# Access Compliance Report

## Public Rights-of-Way

### (Curb Ramps)

Intersection ID: 13769	Main Street: E_3RD_ST	Cross Street: CHERRY_ST	Location: SE
ADA ID: 5015DA0D09B8	Ramp Type: Perp	Initial Pass/Fail: Fail	Overall Compliance: No
Codes/Mitigation Info/Possible Solution		Field Measurements/Component Compliance	
Severity Score: 46.25

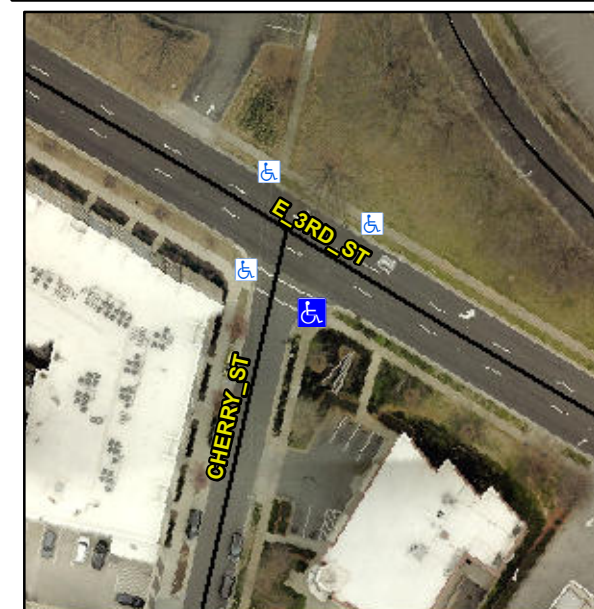
**Not Found, R304.5.1, R304.2.2, R304.5.3**

Compliance	Description	Data	Compliance	Description	Data
N/A	Ramp Length (in)	60.0	No	Ramp Slope (%)	10.3
No	Ramp Width (in)	39.5	No	Ramp XSlope (%)	7.0
N/A	Flare Type LT	N/A	N/A	Flare Type RT	N/A
N/A	Flare Slope LT (%)	N/A	N/A	Flare Slope RT (%)	N/A
N/A	Flare Traversable LT?	N/A	N/A	Flare Traversable RT?	N/A
N/A	Landing Length (in)	N/A	N/A	DWS Provided?	N/A
N/A	Landing Width (in)	N/A	N/A	DWS Contrast?	N/A
N/A	Landing Slope (%)	N/A	N/A	DWS Length (in)	N/A
N/A	Landing X Slope (%)	N/A	N/A	DWS Full Width?	N/A
N/A	Landing Curb? (Y/N)	N/A	N/A	DWS Offset (in)	N/A
N/A	Shared Landing?	N/A			
N/A	Gutter Ponding?	N/A	N/A	Gutter Slope (%)	N/A
N/A	Gutter Lip Ht (in)	N/A	N/A	Gutter X Slope (%)	N/A
N/A	Painted X Walk1?	Yes	N/A	Painted X Walk2?	N/A
	X Walk 1 Direction	To NW		X Walk 2 Direction	N/A
N/A	X Walk 1 Width (in)	104.5	N/A	X Walk 2 Width (in)	N/A
	X Walk 1 Slope (%)	3.7		X Walk 2 Slope (%)	N/A
	X Walk 1 X Slope (%)	3.3		X Walk 2 X Slope (%)	N/A

**Remove & Replace Entire Ramp.**
